Serial No. NA3-08-063R
Docket No. 52-017
COL/MEP

DOMINION VIRGINIA POWER
NORTH ANNA UNIT 3 COMBINED LICENSE APPLICATION
RESPONSE TO REQUEST FOR ADDITIONAL INFORMATION LETTER NO. 011

Response to NRC RAI Letter 011

Response to RAI 12.02-2, Figure: Source and Receptor Locations

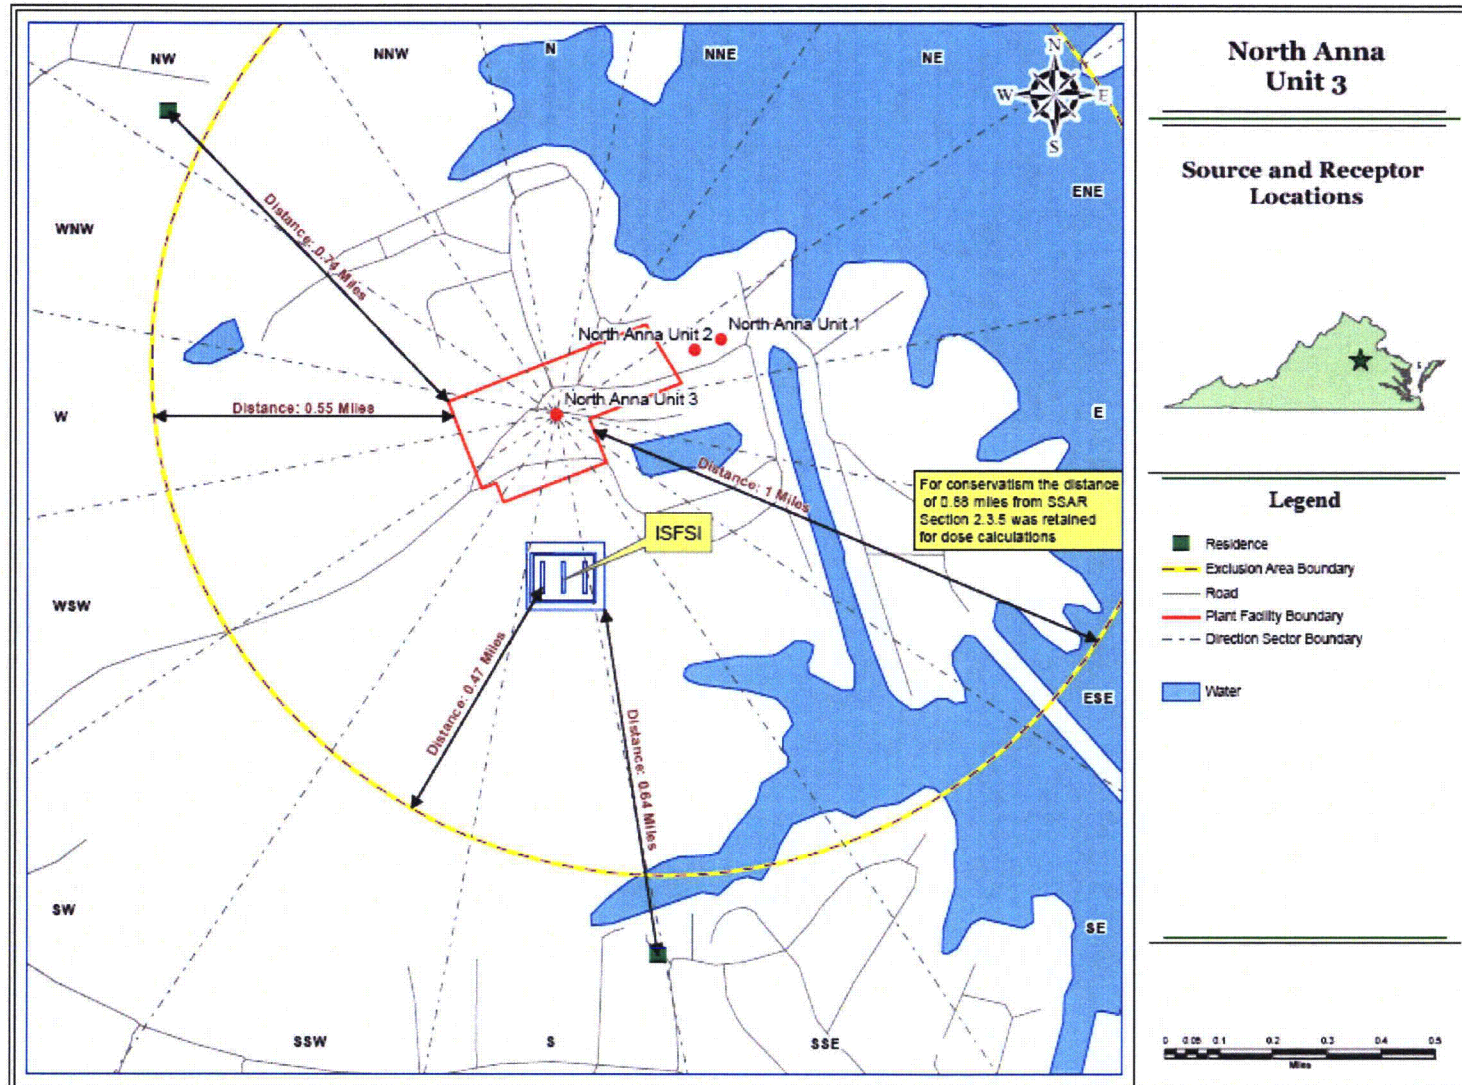
NRC RAI 12.02-2

FSAR Section 12.2.2.4.4, Compliance with 10 CFR Part 20.1301 and 20.1302, presents an updated analysis of doses to the maximally exposed individual and compares dose results against the EPA environmental dose standards of 40 CFR Part 190, as implemented under Part 20.1301(e). Discussion is presented on page 12-7 and the results presented in Table 12.2-203. Although the discussion points out that the dose from direct external radiation has been considered in the evaluation, it is not clear if the analysis considered increased external radiation levels at the nearest residence associated with the use of hydrogen water chemistry. The FSAR discussion (p.12-7) addresses annual dose rates at the EAB (ESE at 1416 m), while the distance to the nearest resident is closer to the site (ESE at 1191 m, FSAR Table 12.2-18bR, p.12-16). DCD, Revision 4, Section 12.2.1.3 acknowledges increased external radiation levels whenever hydrogen water chemistry is used and presents the results of a generic analysis (OCD Table 12.2-21) using arbitrary site conditions and distance only for the EAB. Accordingly, please revise Section 12.2.2.4.4 to demonstrate that, when added to the dose contribution from all other direct sources of external radiation to the nearest residence, the sum of all direct sources of radiation will not exceed the dose standards of 40 CFR Part 190 and 10 CFR Part 20.1301(e). In addition, please provide sufficient information for the staff to evaluate the basis and assumptions used in this analysis for the purpose of conducting an independent confirmation of compliance with NRC and EPA regulations.

FSAR Section 12.2.2.4.4 addresses the dose contributions from direct external radiation due to operation of Unit 3 (including the use of hydrogen water chemistry), operation of Units 1 and 2, and operation of the NAPS Independent Spent Fuel Storage Installation (ISFSI). These three sources contribute to direct external radiation doses both at the residence nearest each type of source and at the site boundary location with the highest gaseous effluent annual doses. FSAR Section 12.2.2.4.4 will be revised to more clearly account for direct radiation dose contributions at both types of receptor locations due to these three sources. Please refer to the attached figure, Source and Receptor Locations, which helps visualize the locations described below.

Note that the attached figure, Source and Receptor Locations, shows the residence nearest the ISFSI is located in the S sector from Unit 3. This location was obtained this year from a survey of receptor locations for Unit 3 and is a revision for the S sector from what is presented in FSAR Table 2.3-15R. That table shows no residence in the S sector. FSAR Table 2.3-15R will be updated for the next submittal of the FSAR, but the conclusion from that table will not change. The closest receptor to Unit 3 remains the residence in the NW sector. Because it was conservatively assumed that each receptor (meat animal, vegetable garden, residence) is at the distance of the closest receptor but in the direction of the maximum X/Q values, there will be no impacts on the gaseous effluent doses estimated for Unit 3. That is, although information for some of the receptors in FSAR Table 2.3-15R will be changing in the next FSAR submittal, the significant value in that table for the dose calculation, the distance of 0.74 mi to the receptor (residence in the NW sector), was confirmed and has not changed.
